From: Lyle Misbach
Sent: Tuesday, July 31, 2018 6:53 AM
To: Amy Johnson
Subject: FW: ORD 15-18
Attachments: Misbach Questions.doc

The attach document raises several questions regarding the update to Chapter 601 of the Salem Revised Code. Please advise process I need to follow to secure answers.

Below is a screen shot from Salem Zone Code section 7322N PDF containing the Wallace Marine Park and the new West Salem Central Business Zone.

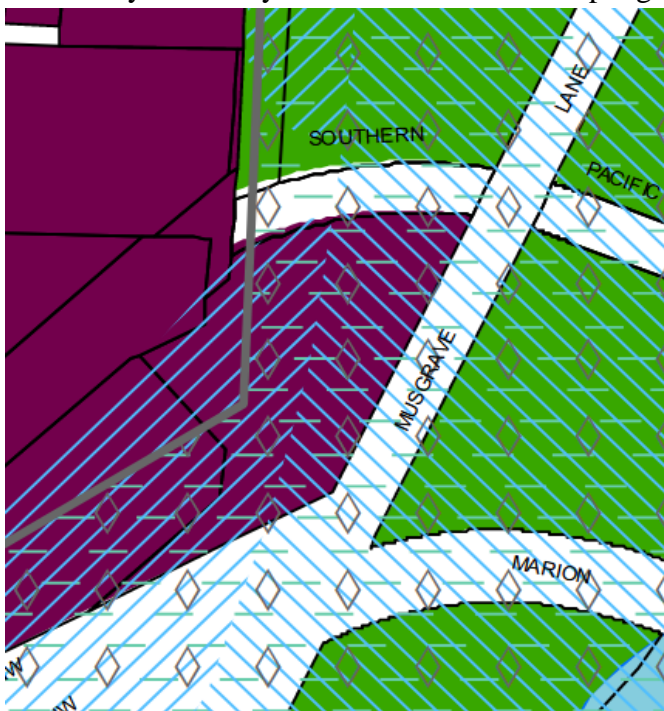
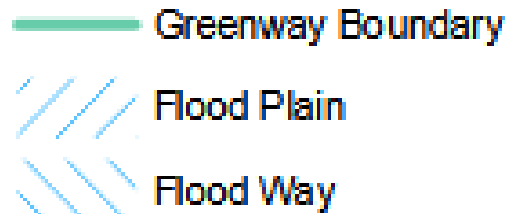
I note that the graphic does not appear to include the Greenway Boundary Line included in the map legend/key.

The graphic to the left is an enlargement of the section above. By carefully tracing the light blue lines I can see the boundary between the Flood Way and Flood Plain.

CA18-03?

Will this boundary information be revised with the adoption of

At this point along the Willamette what is nominal elevation

divider between

the Flood Plan and the Flood Way?
